# SERVICE No. 496 BULLETIN

Piper Aircraft Corporation

Stabilator Balance Weight Tube Replacement.

PA-24-250 Comanche

Detail "A" :

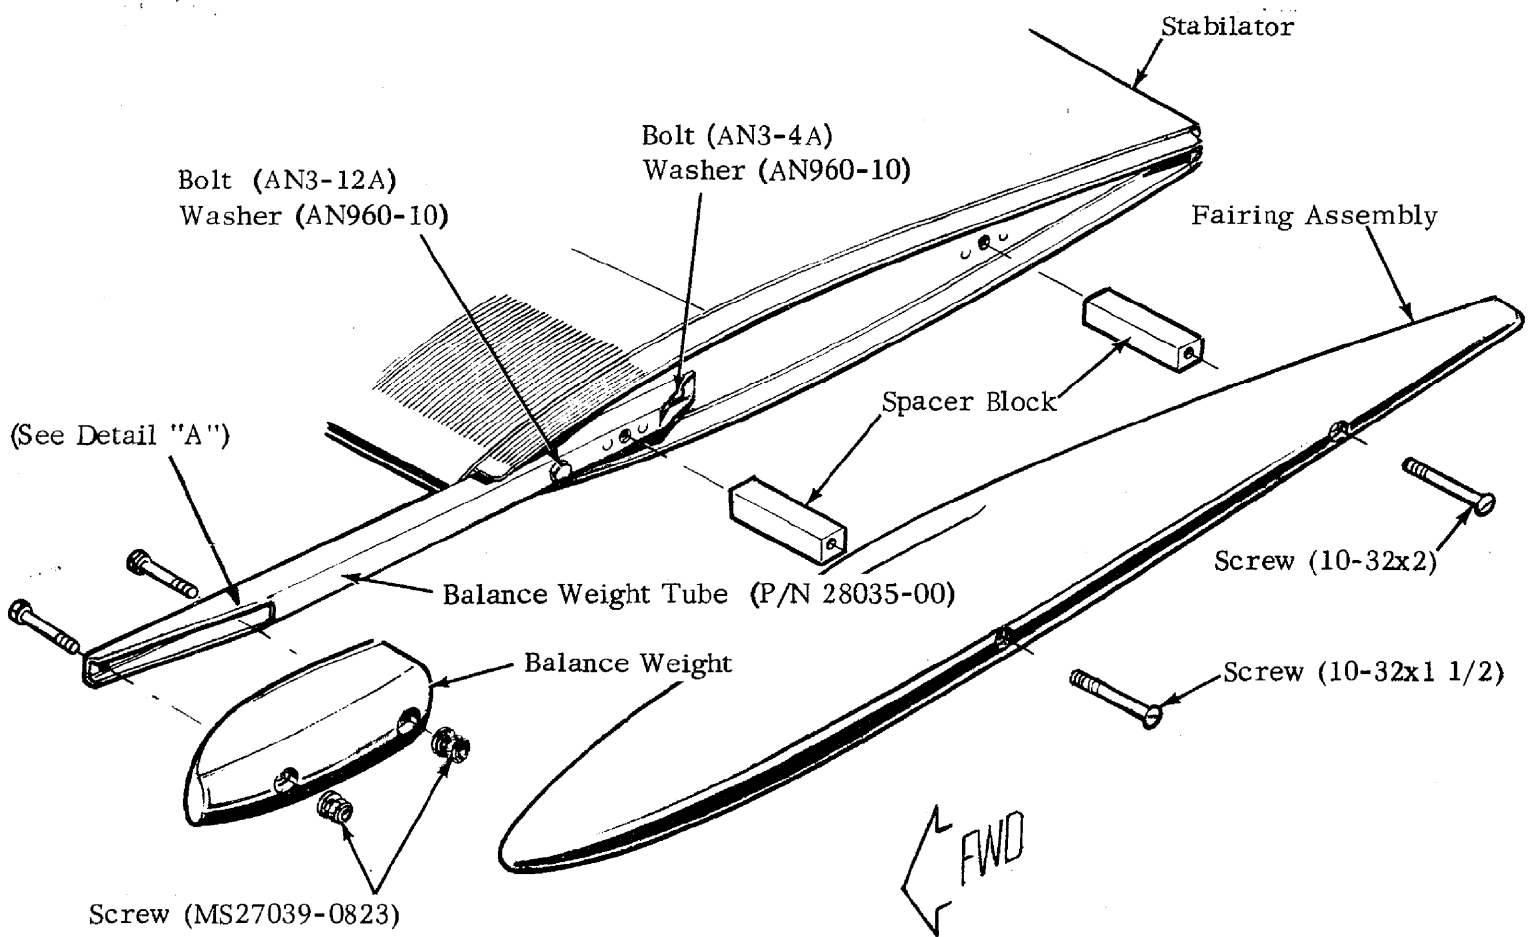
Piper Service Letter No. 687 dated June 19, 1974, announced the availability of Stabilator Modification Kit Piper Part Number 760 747 for the above referenced aircraft. Recent factory testing indicates that cracks may develop in the stabilator balance weight tube assembly (part number 28035-00, supplied with the above referenced modification kit) in the corners of the balance weight cutout.

This service release provides material to replace the stabilator balance weight tubes on aircraft that have had stabilator modification kit, Piper part number 760 747 previously installed. New stabilator balance weight tubes are provided and are redesigned with a reshaped balance weight cutout (radius cut corners) to preclude corner cracks.

Previous Tube - "squared" corners

New Tube - rounded cutout

1. Remove fairing assembly and balance weight from left and right stabilators.
2. Remove existing balance weight tubes and install new tubes P/N 28035-00.  
Torque bolts to 20-25 inch pounds.
3. Reinstall balance weight and torque screws to 7-9 inch pounds.
4. Reinstall fairing assembly.
5. Make appropriate log book entry.
